VERMONT YANKEE NUCLEAR POWER CORPORATION

Proposed Change No. 118

FVY 84-9

Subject: Reactor Vessel Pressure Temperature Curves

Figure 3.6.1
 Reactor Vessel Pressure
 Temperature Limitations
 for Operation Through 1.330E2MWH
 $RT_{NDT} @ 1/4T = +92^{\circ}F @ 3/4T = 75^{\circ}F(t)$
 $RT_{NDT} (closure flange) = 60^{\circ}F$

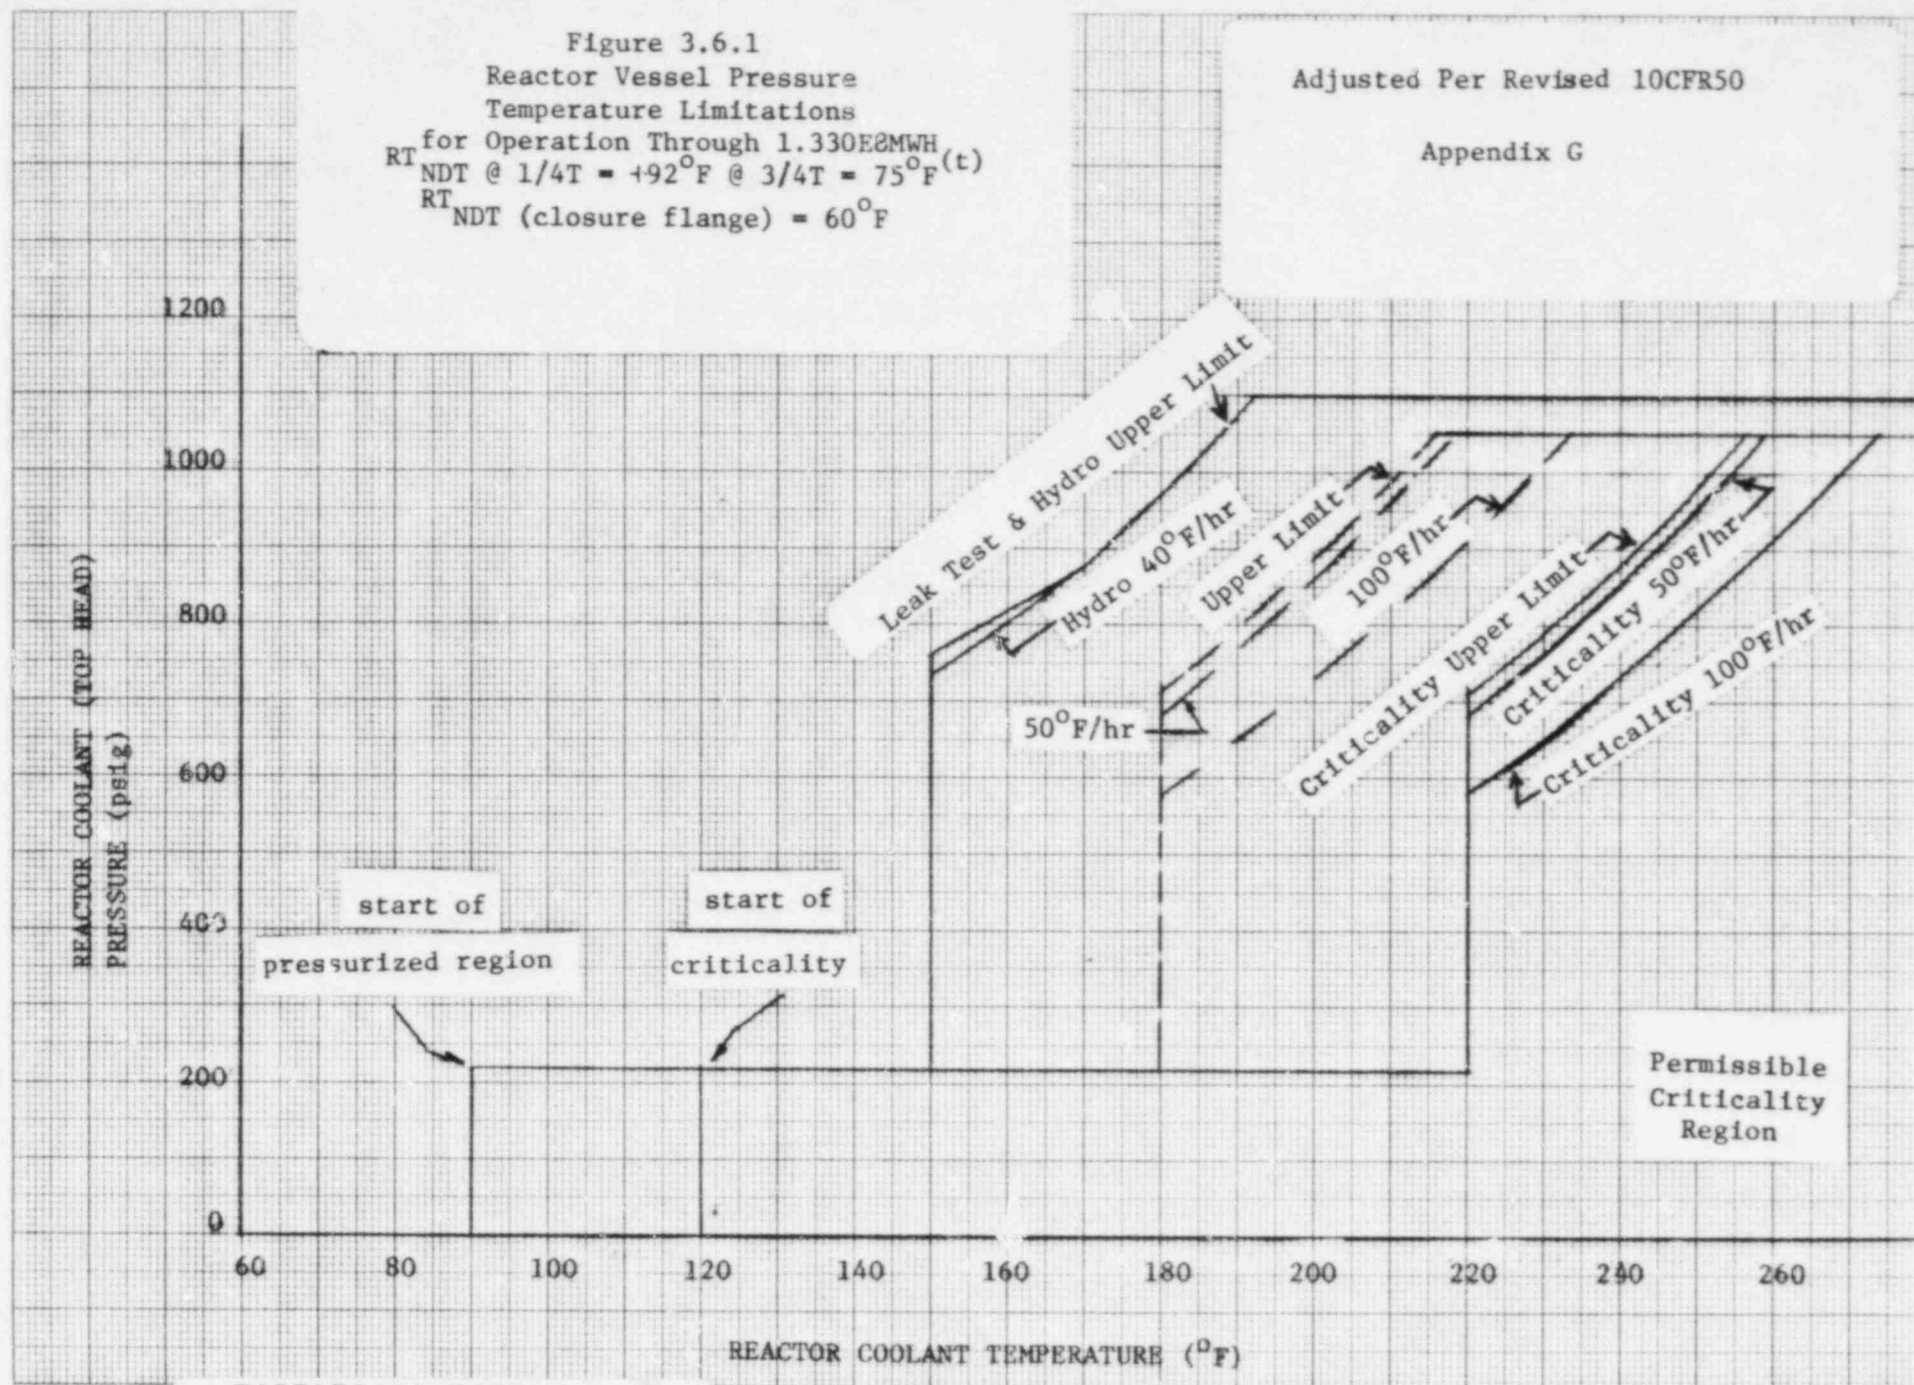
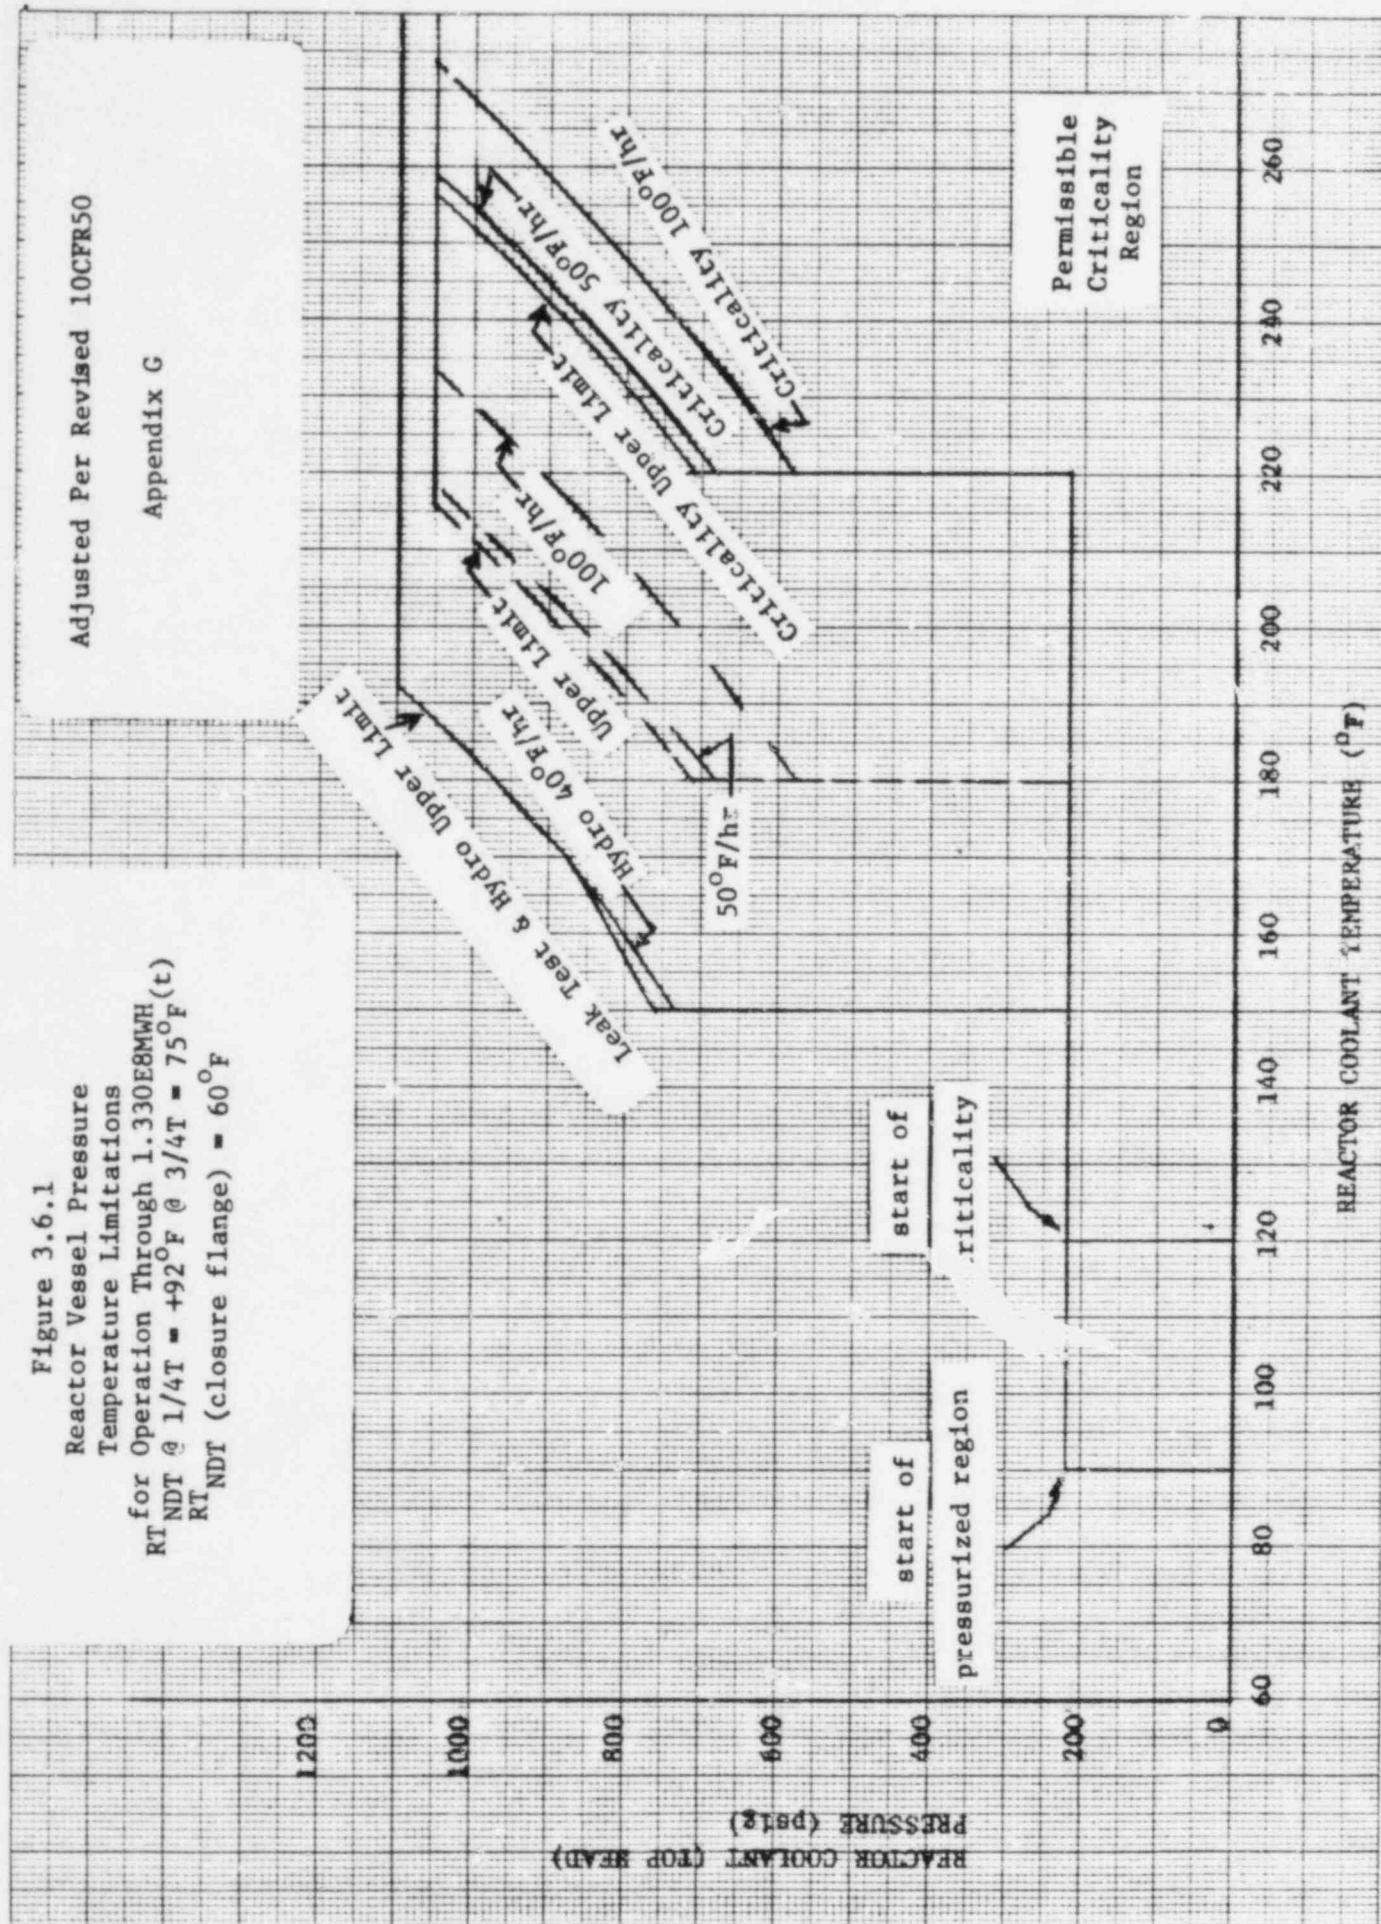
Figure 3.6.1, "Reactor Vessel Pressure Temperature Limits for Operation Through 1.15E8 MWh(t)" has been updated to reflect allowable heatup curves for reactor operation through a power output of 1.330E8 MWh(t). The revised figure also reflects the promulgation of a revision to 10CFR Part 50, Appendix G [Reference (c)]. Pages 117 and 118 have been revised to reflect a change to the bases section of the Technical Specifications.

This change adjusts the curves of Figure 3.6.1 to compensate for the effects of increased neutron exposure to permit operation to a power level of 1.330E8 MWh(t). This adjustment is necessary because the existing curves are limited to a power output of 1.15E8 MWh(t), a value which is expected to be reached during March 1984.

1. Removal (for BWRs) of the hydrostatic pressure test temperature limit for criticality. The new temperature limit for criticality is the RT_{NDT} of the closure flange plus 60°F. For Vermont Yankee, this will be 120°F (the former temperature was 173.5°F). This value is applicable at pressures <220 psig. At pressures \geq 220, the criticality curves are a continuation of the previous curves based on 10CFR50, Appendix G, which requires that vessel temperature always be 40°F above the ASME Code, Section III, Appendix G, calculated curves during criticality.

2. Limiting normal operation and hydrotest to pressures below 220 psig until vessel closure flange temperature is well above RT_{NDT} of closure flange region. Specifically, when pressure exceeds 220 psig, the new hydrotest temperature is RT_{NDT} of the closure flange plus 90°F. This temperature is 150°F. In addition, when pressure exceeds 220 psig, the new normal operation temperature is $[RT_{NDT}]_{CF}$ plus 120°F = 180°F.

Vermont Yankee's vessel closure flange is ASME SA 508, C1 2 material. Because no fracture toughness test data for this material is available, its reference temperature (RT_{NDT}) is defined by "Standard Review Plan", Section 5.3.2, Pressure Temperature Limits, and Branch Technical Position MTEB 5-2, "Fracture Toughness Requirements for Older Plants". That temperature is 60°F.

The closure flange is located in a low neutron fluence area, i.e., out of the "vessel beltline", and therefore no measurable RT_{NDT} shift is expected over plant life.
